ORIGINATION FORM

Proposed Revisions to a Standard Plans Index
(Please provide all information — Incomplete forms will be returned)

Index Number: 700-041
Sheet Number (s): 2 of 5
Index Title: Span Sign Structure

LAST REVISION 11/01/21	REVISION	DESCRIPTION:	 FY 2022-23 STANDARD PLANS	SPAN SIGN STRUCTURE	INDEX 700-041	SHEET 2 of 5
---------------------------	----------	--------------	---	---------------------	------------------	-----------------

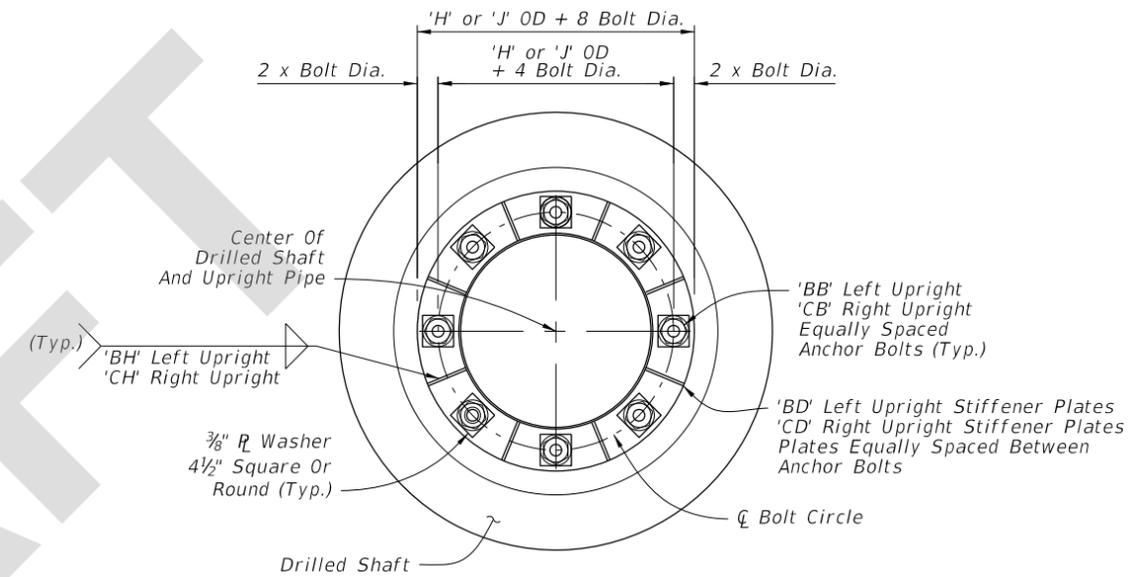
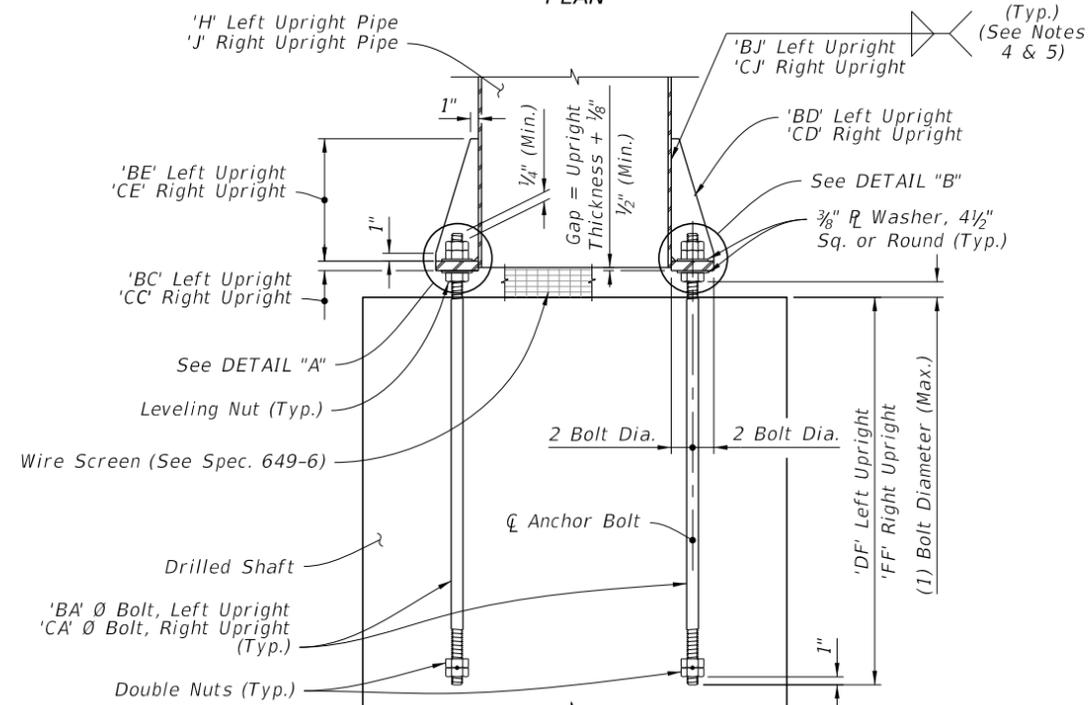
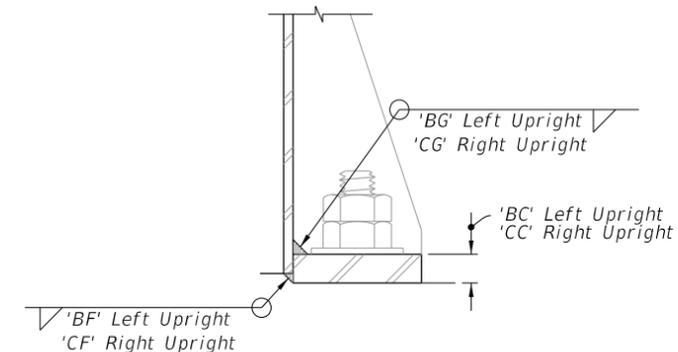
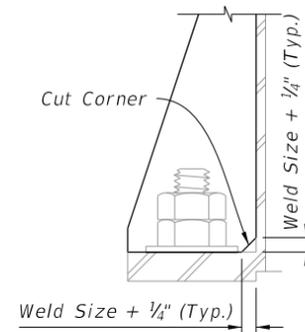
Revised Note 5 to read "After galvanizing, provide magnetic particle testing on 100% of upright fillet welds."

During maintenance inspections, weld cracks were found on in-service overhead sign structure supports. A FDOT investigation determined the cracks were formed during fabrication. To implement a better fabrication quality control processes, the note on the Standard is being changed.

- NOTES:**
1. See Traffic Plans for elevation at top of Foundation.
 2. Install Drilled Shaft with a 2'-0" minimum from top elevation of the drill shaft to the finished grade, unless specified otherwise in the plans.
 3. The shaft length is based on 2'-0" height above finished grade.
 4. Wrap fillet weld around the stiffener termination on the tube wall (Typ).
 5. After galvanizing, provide magnetic particle testing on 100% of upright fillet welds.
